## **3.0 DESIGN OF STRUCTURES, COMPONENTS, EQUIPMENT AND SYSTEMS**

**Figure 3.7.1-1. Comparison of the horizontal FIRS at the elevations of -7 m (-24 ft) and +3.3 m (+11 ft) calculated by the NRC staff, the horizontal FIRS at the same elevations calculated by the applicant, and the Westinghouse CSRDS.**

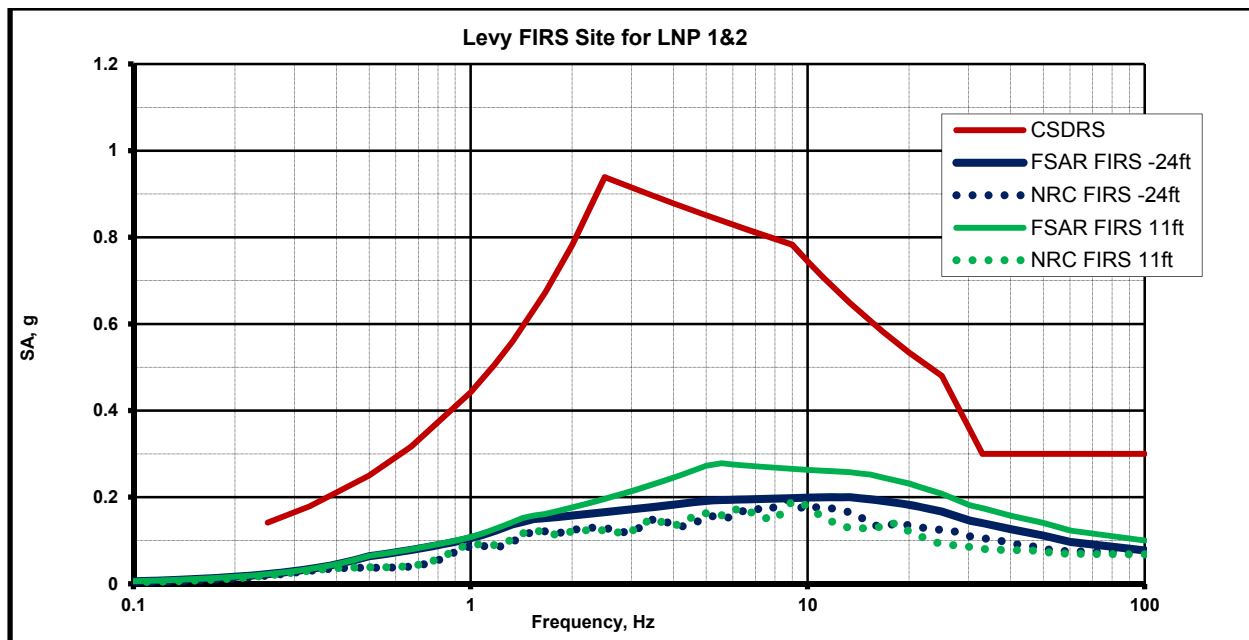
The staff performed confirmatory calculations for both FIRS using the same approach as described above for the PBSRS. For the  $V_s$  profiles for the FIRS at the elevation of -7 m (-24 ft), the staff used profiles shown in FSAR Tables 2.5.2-222 and 2.5.2-223. Modifications to these  $V_s$  profiles were made by removing the layers in the upper 15 m (50 ft). Figure 3.7.1-1 compares the staff's calculation of the FIRS with the CSDRS and FSAR (Fig.3.7-201).

The set of site amplification functions for the FIRS at the elevation of +3.3 m (+11 ft) was calculated using 10.7 m (35 ft) of concrete with  $V_s$  of 1066 m/s (3500 ft/s) (FSAR Table 2.5.4.5-201) on the top of profile used for the FIRS at the elevation of -7 m (-24 ft). Figure 3.7.1-1 compares the staff's calculation of FIRS with CSDRS and the applicant's from the LNP Unit 1 and 2 FSAR (Figure 3.7-205).

The staff's calculation of the FIRS at both elevations of -7 m (-24 ft) and +3.3 m (+11 ft) are enveloped by the applicant's FIRS and by the CSRDS. Therefore, the staff concludes that in the frequency range significant to a reactor's structures, systems, and components, there are no significant differences between the staff's and the applicant's calculated amplification functions and FIRS for the  $10^{-4}$  and  $10^{-5}$  hazard levels.
